Town of Parker Community Development Department
Development Review Division
Attention: **Stacey Nerger**

Application Type: **Site Plan**
Status: **First Referral**
Application Name: **Parker and Pine F1 L2 - Gas Station & Conv. Store**
Case/AP#: **SP20-0019**
Referral Received: April 8, 2020
Comments Due: May 6, 2020

Review date: **April 27, 2020**
Plan reviewer: **Randall L. Capra, rcapra@parkeronline.org**
Phone: 303.805.3169

TOWN OF PARKER - FIRE/LIFE SAFETY:	R REVIEWED FOR CODE COMPLIANCE; REVISIONS REQUIRED
---	---

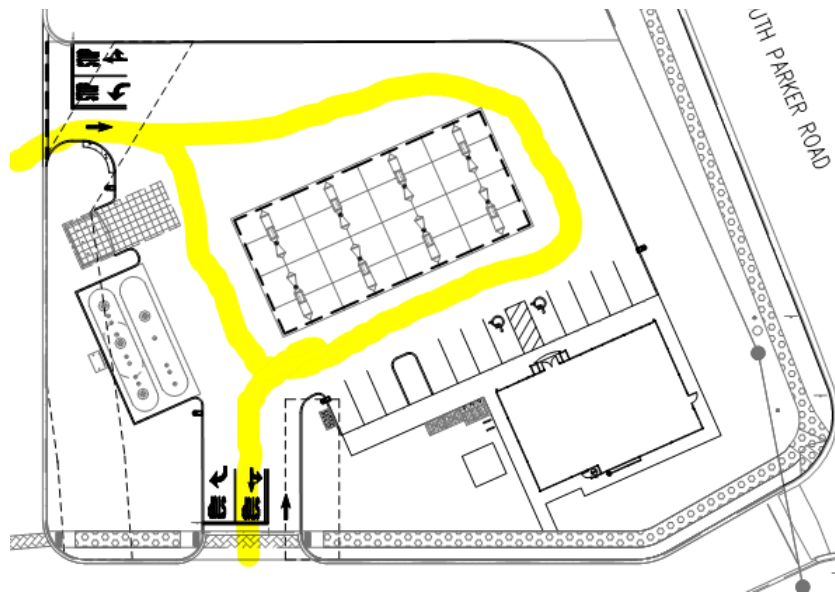
For the applicant's clarity, I have provided a marked up site plan to address the crucial elements of this site; access, as shown, must be provided at all times.

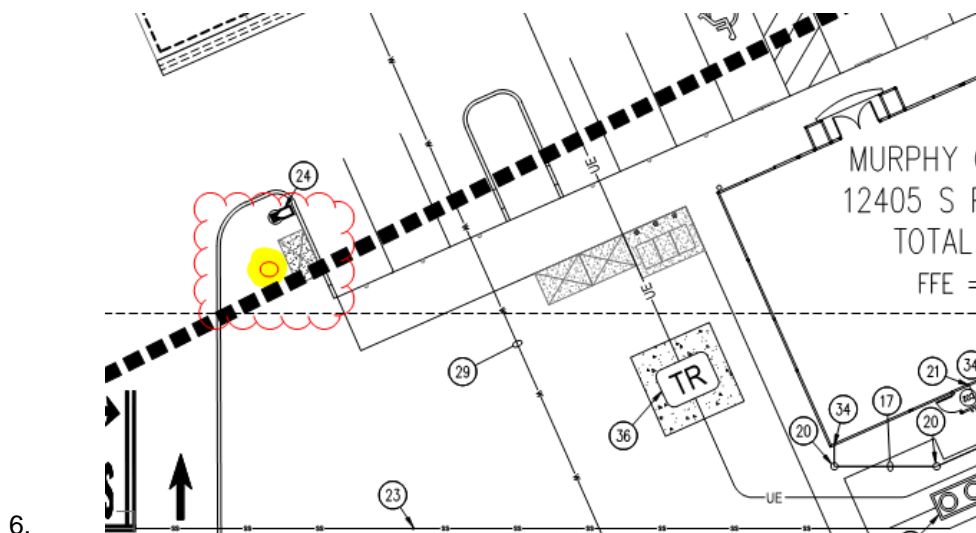
5. The applicant shall provide a fire hydrant in the island shown below; address this issue when resubmitting. *Satisfied; applicant has addressed with current submittal.*
